Agenda
Village of Arlington Heights
Design Commission
Community Room, 3rd Floor

Arlington Heights Village Hall
33 S. Arlington Heights Road
Arlington Heights, IL 60005
August 25, 2015
6:30 PM

- A. DC#15-095 - 922 N. Beverly Ln. - SF/Teardown
- B. DC#15-101 - 1138 N. Mitchell Ave. - SF/Teardown
- C. DC#15-098 - Olive-Mary Stitt School - 303 E. Olive St.
- D. DC#15-099 - Ivy Hill School - 2211 N. Burke Dr.
- E. DC#15-096 - The Moorings - 811 E. Central Rd. - Institutional

LEFT SIDE ELEVATION

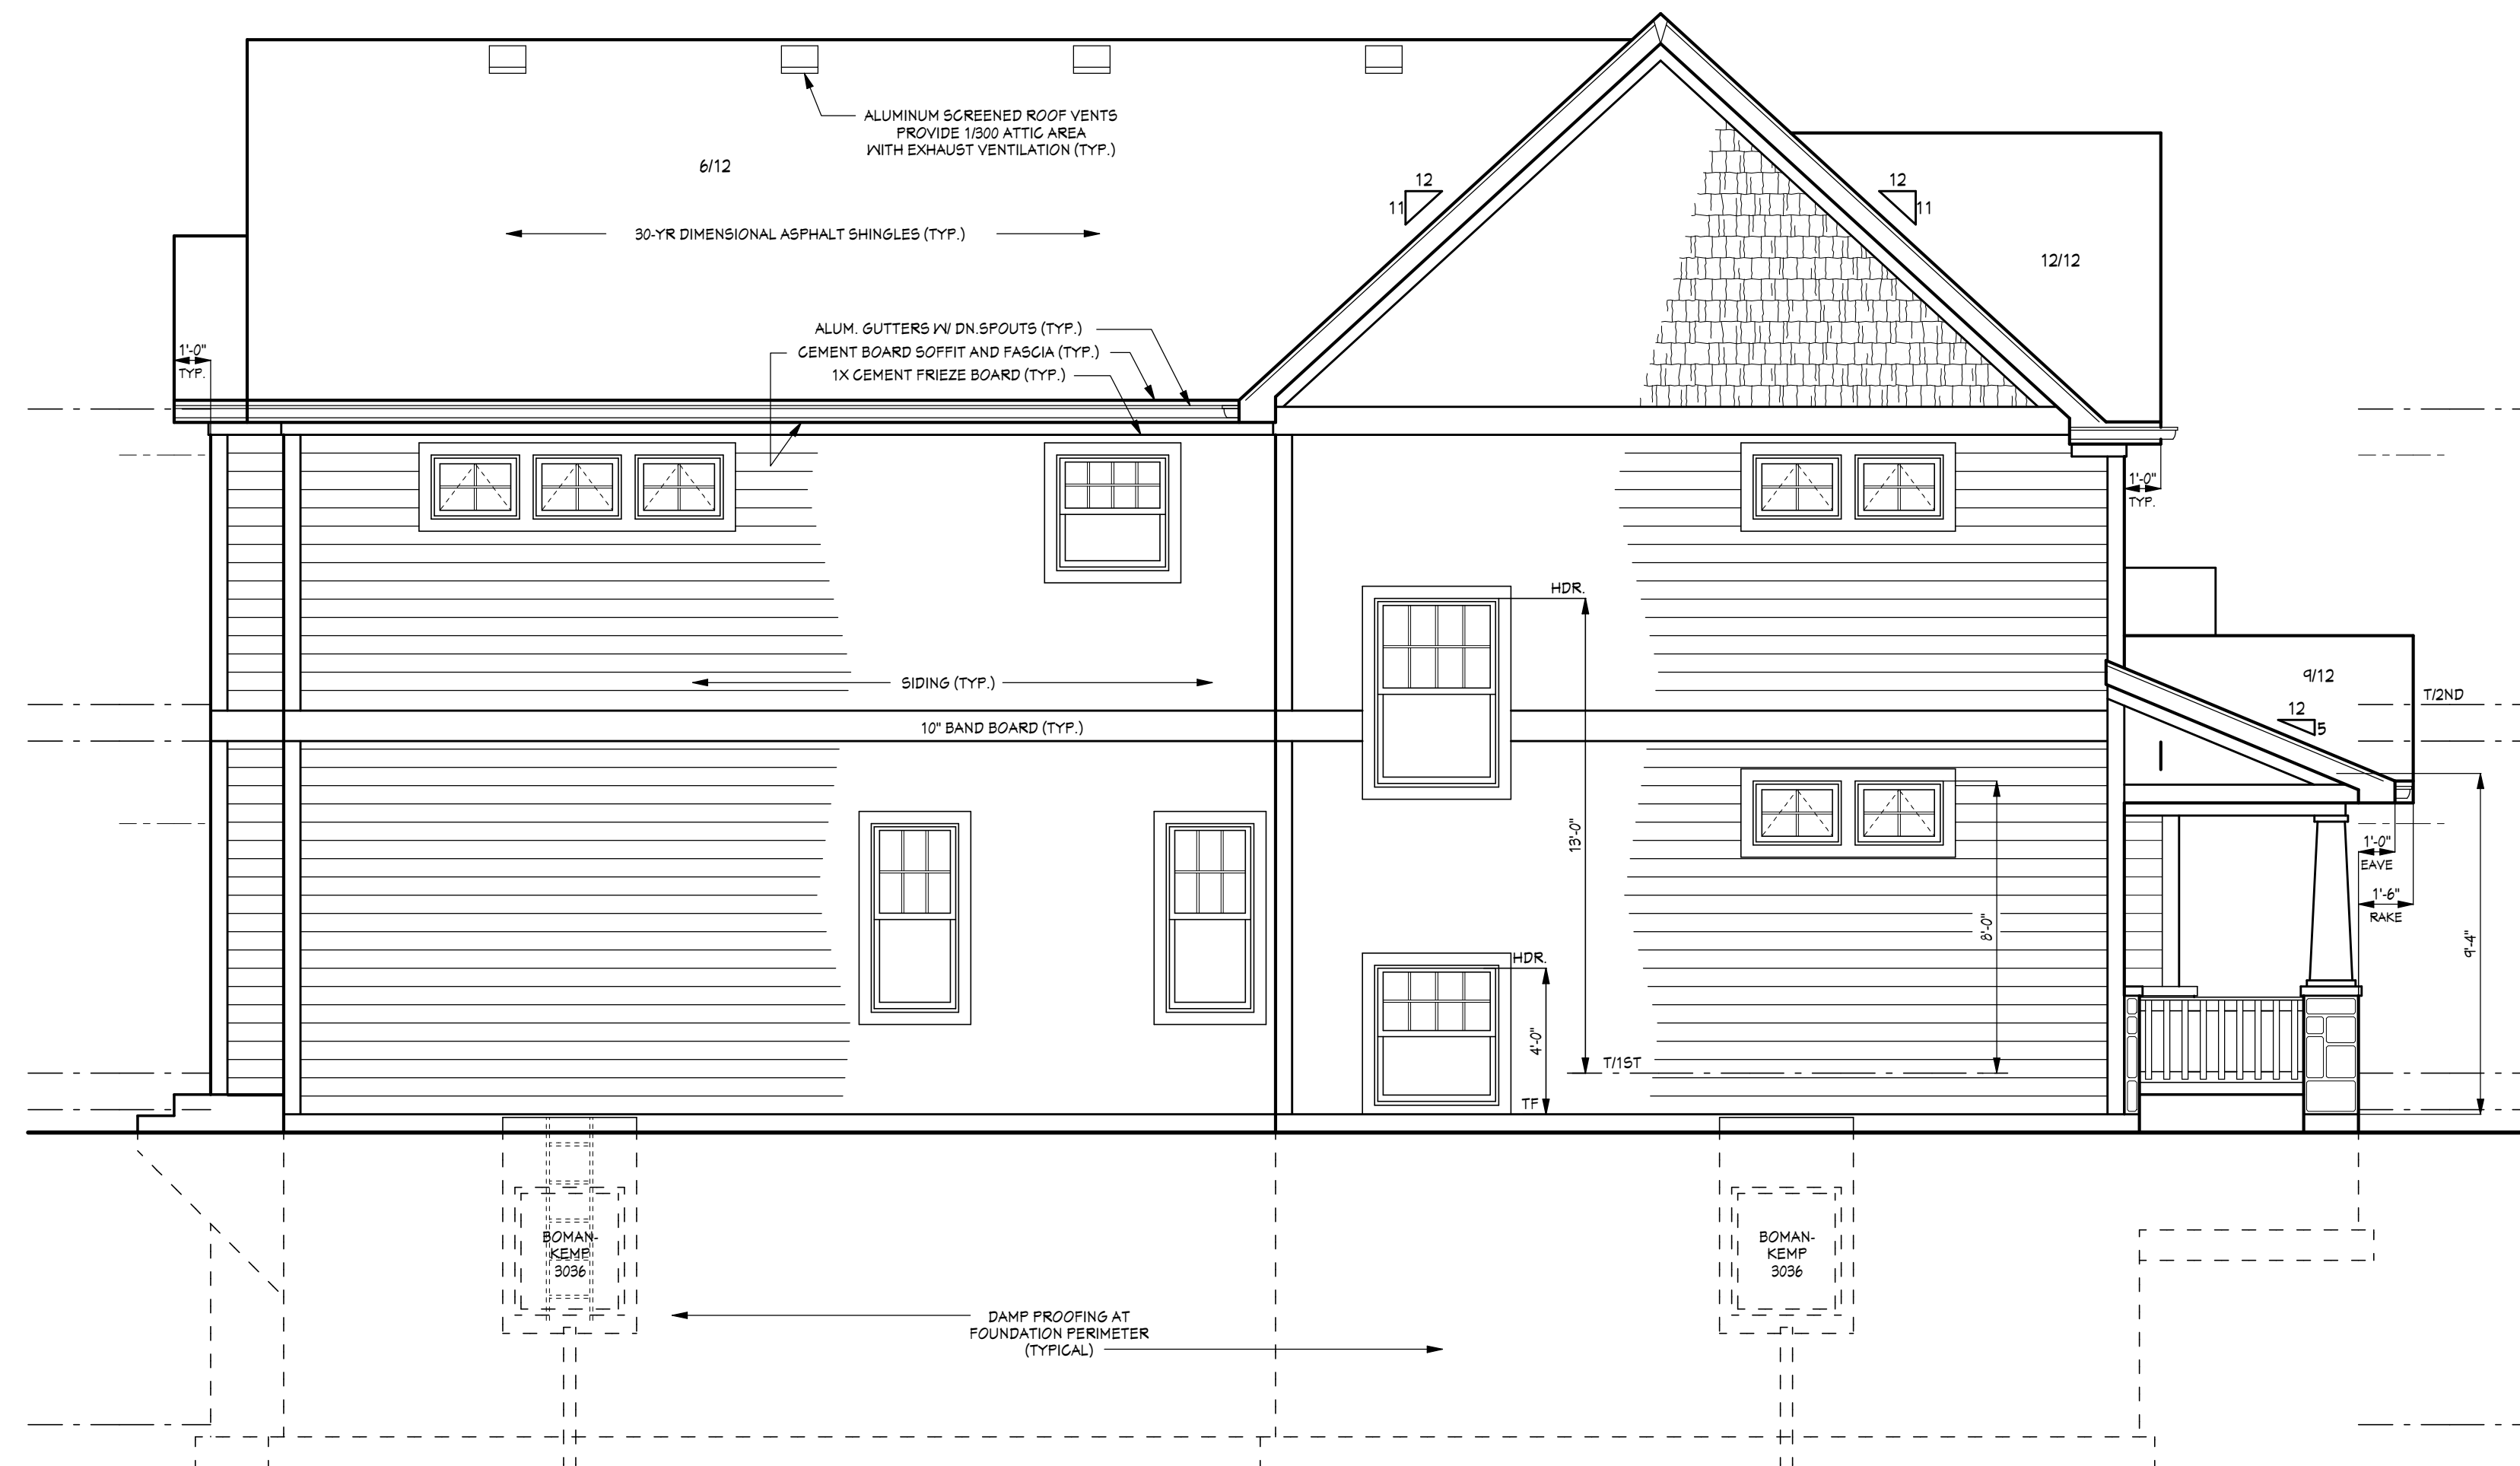
1. Add some additional windows to the side elevations to break up the large blank walls.
2. This review deals with architectural design only and should not be construed to be an approval of, or to have any other impact on, any other zoning and/or land use issues or decisions that stem from zoning, building, signage or any other reviews. In addition to the normal technical review, permit drawings will be reviewed for consistency with the Design Commission and any other Commission or Board approval conditions. It is the architect/homeowner/builder's responsibility to comply with the Design Commission approval and ensure that building permit plans comply with all zoning code, building permit and signage requirements.
3. Compliance with all applicable Federal, State, and Village codes, regulations and policies.

RIGHT SIDE ELEVATION

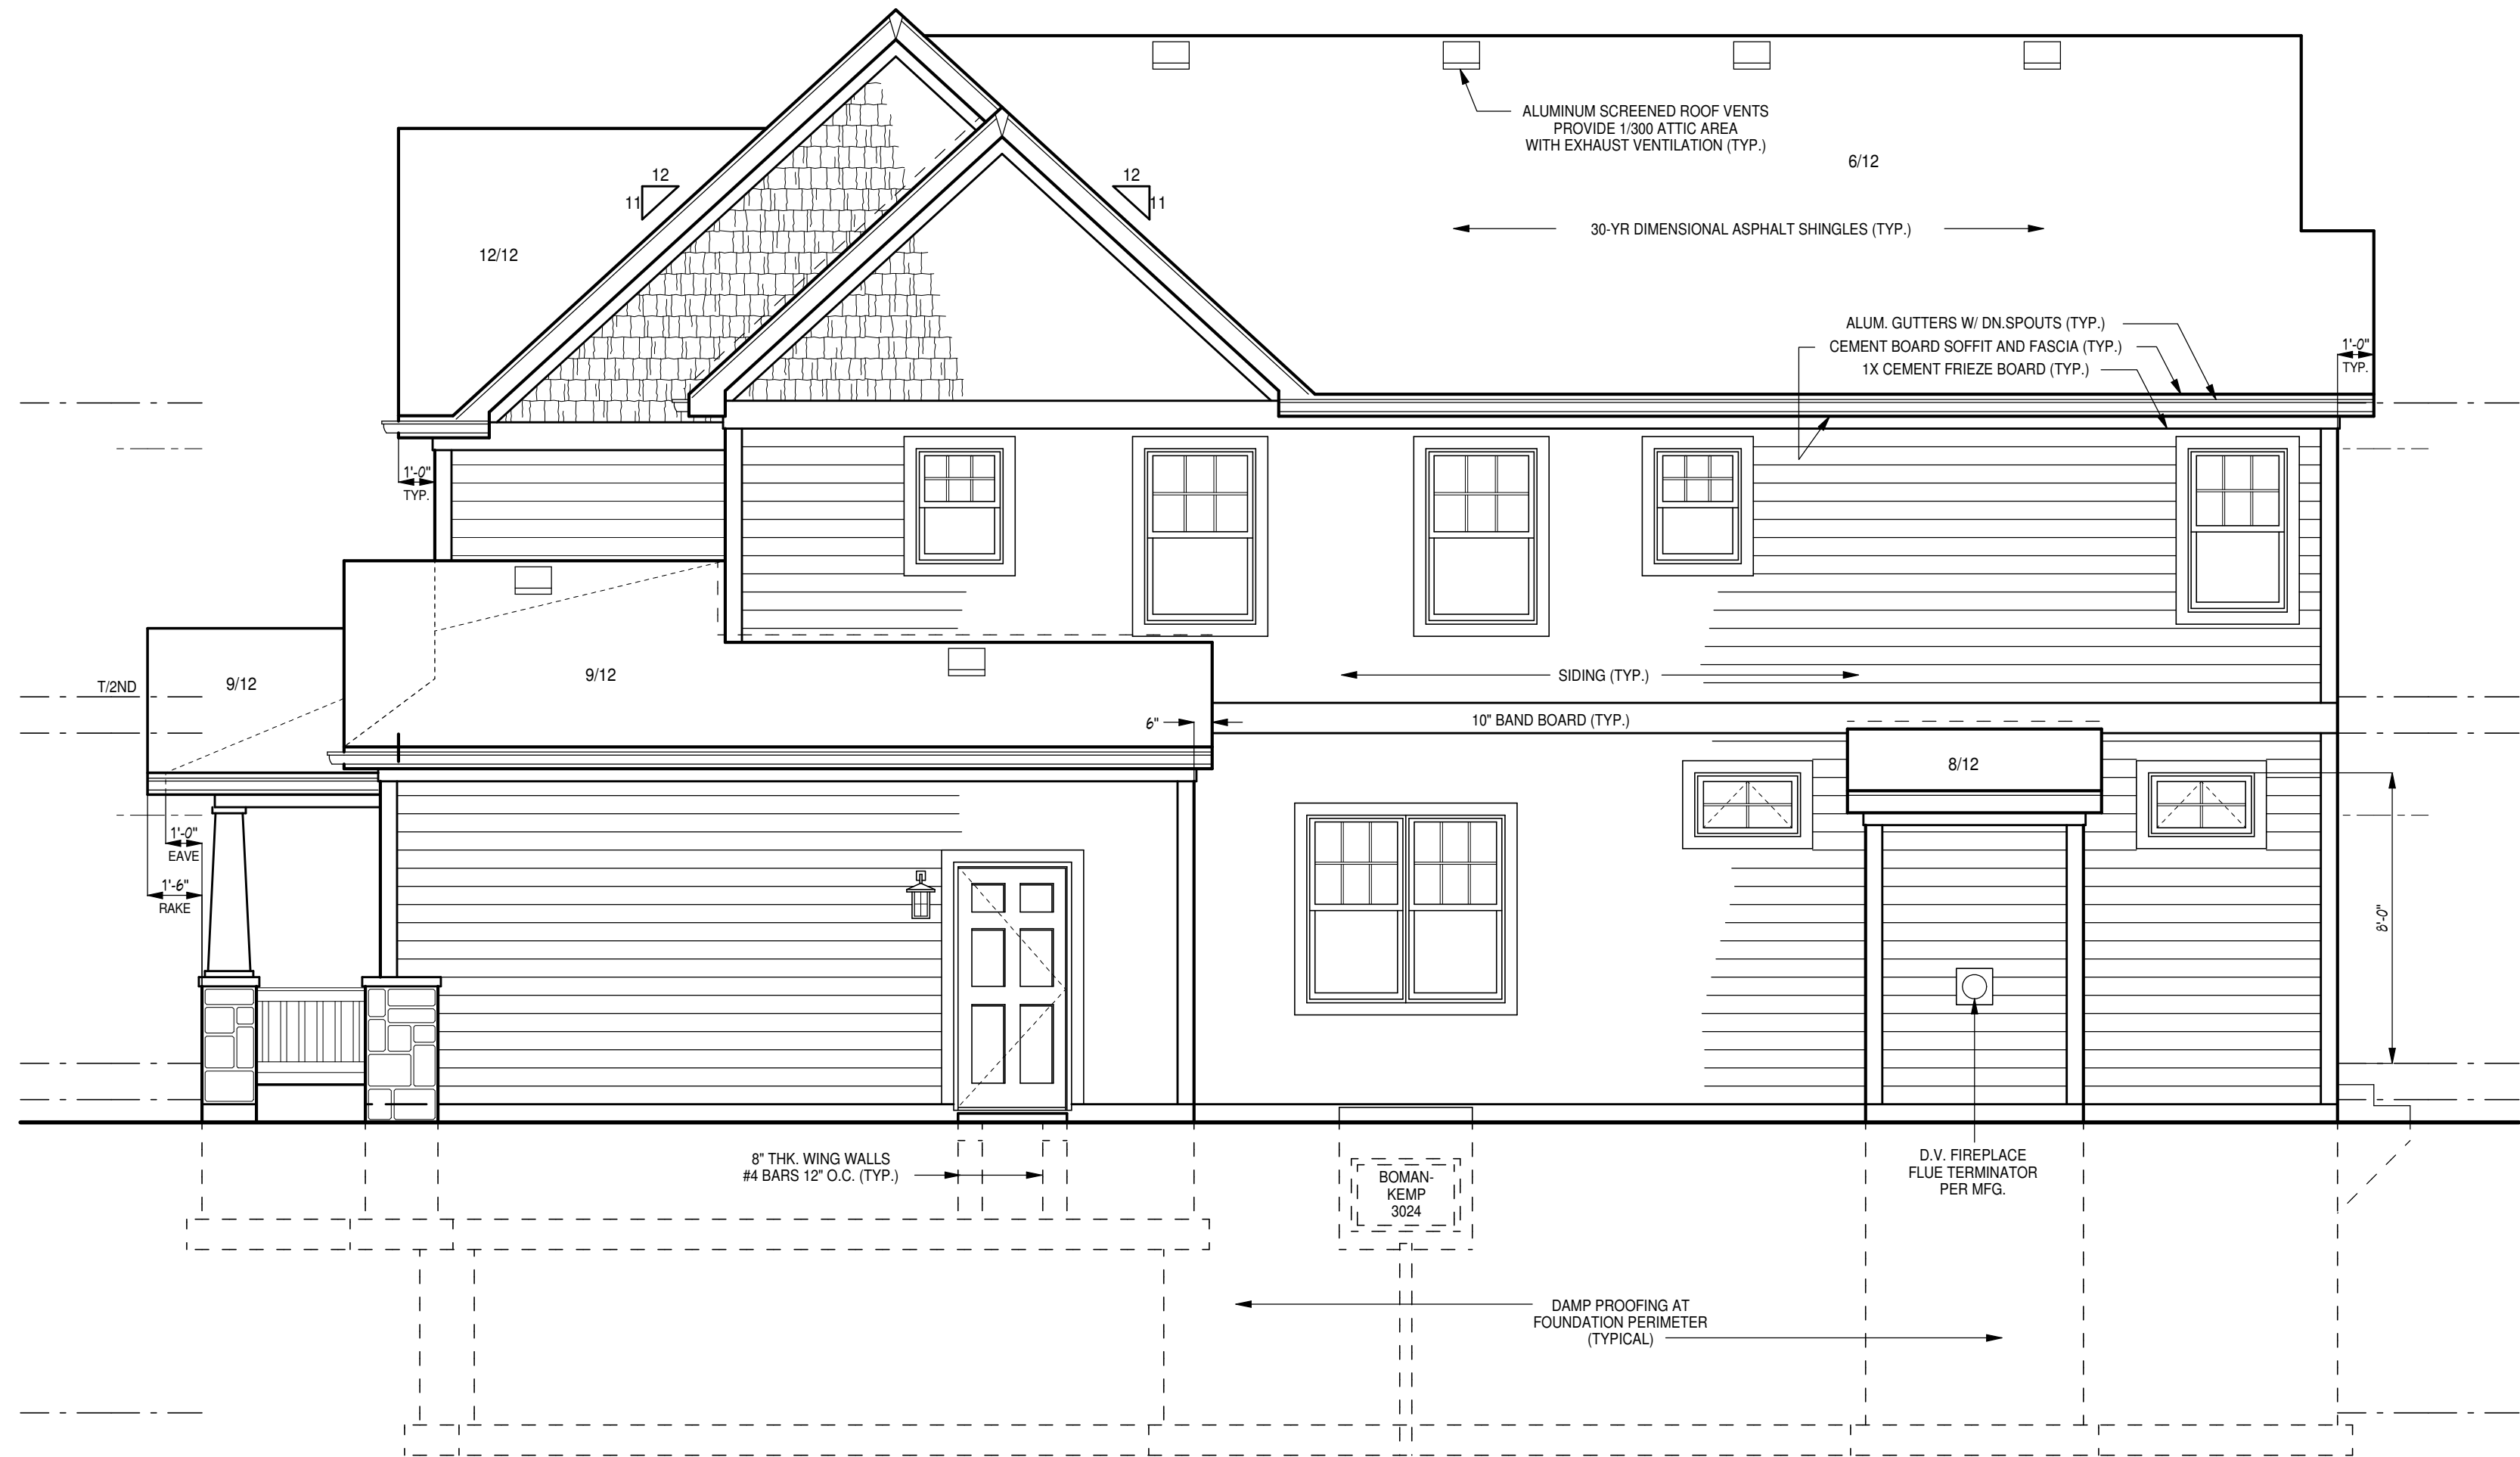
1. Add some additional windows to the side elevations to break up the large blank walls.
2. This review deals with architectural design only and should not be construed to be an approval of, or to have any other impact on, any other zoning and/or land use issues or decisions that stem from zoning, building, signage or any other reviews. In addition to the normal technical review, permit drawings will be reviewed for consistency with the Design Commission and any other Commission or Board approval conditions. It is the architect/homeowner/builder's responsibility to comply with the Design
